**IEEE P802.15
Wireless Personal Area Networks**

Project	IEEE P802.15 Working Group for Wireless Personal Area Networks (WPANs)
Title	UWB Packet Format Configuration
Date Submitted	02 December 2024
Source	Billy Verso (Qorvo), billy.verso at qorvo.com
Re:	IEEE P802.15.4ab Comment Resolutions
Abstract	Comment Resolutions for selected comments on the LB207 / P802.15.4ab D01.
Purpose	This document provides text changes intended to be part of the final IEEE Std 802.15.4ab (amendment to IEEE Std 802.15.4), as part of resolving selected comments from the consolidated spreadsheet (doc 15-24-0371) that have been assigned to the author to resolve.
Notice	This document does not represent the agreed views of the IEEE 802.15 Working Group or IEEE 802.15.8 Task Group. It represents only the views of the participants listed in the "Source(s)" field above. It is offered as a basis for discussion and is not binding on the contributing individual(s) or organization(s). The material in this document is subject to change in form and content after further study. The contributor(s) reserve(s) the right to add, amend or withdraw material contained herein.

Figure 198—HRP-ARDEV MMS packet formats

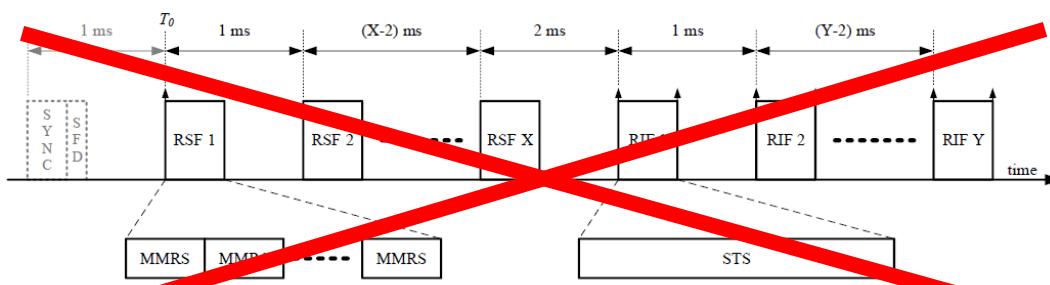
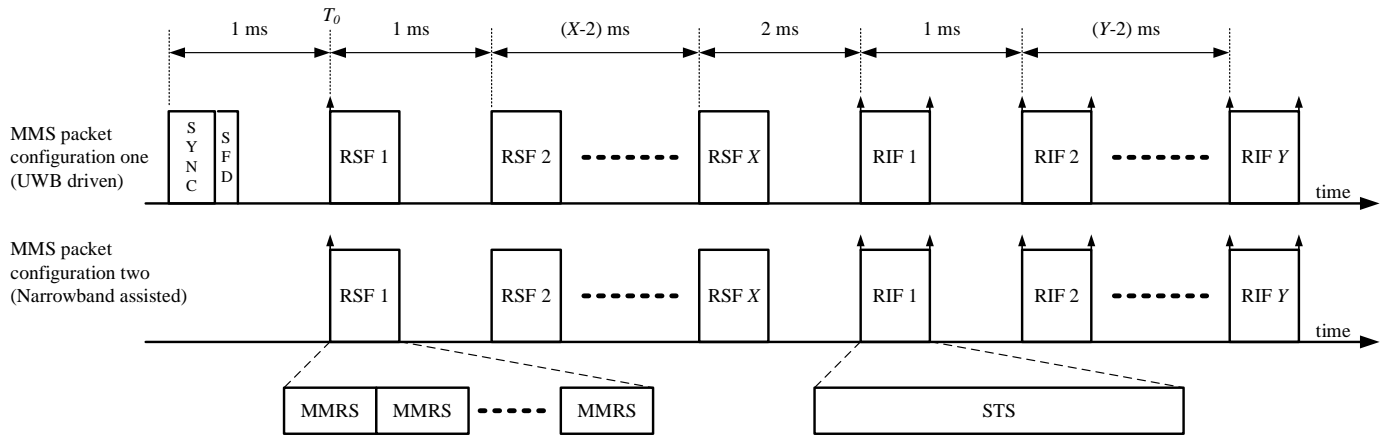
Now Figure 198 referenced in the Table X above needs update to show the two MMS packet formats separately. (This was also in 0552r1)

Replace current figure 198

Figure 10-206—Message sequence chart for SS-TWR using SP3 packets

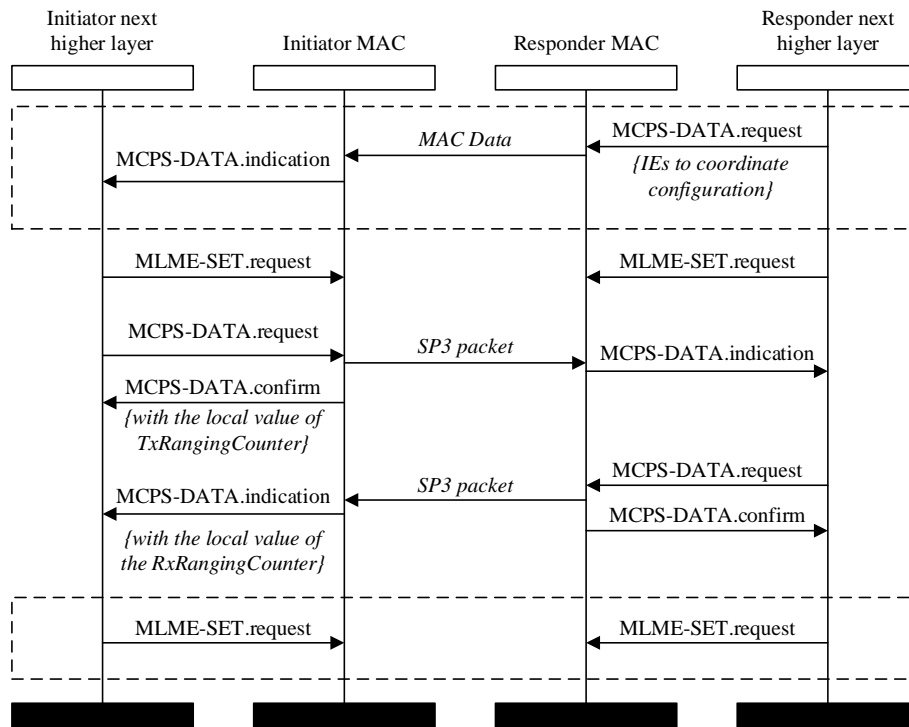
Replace Figure 10-206 with the following:
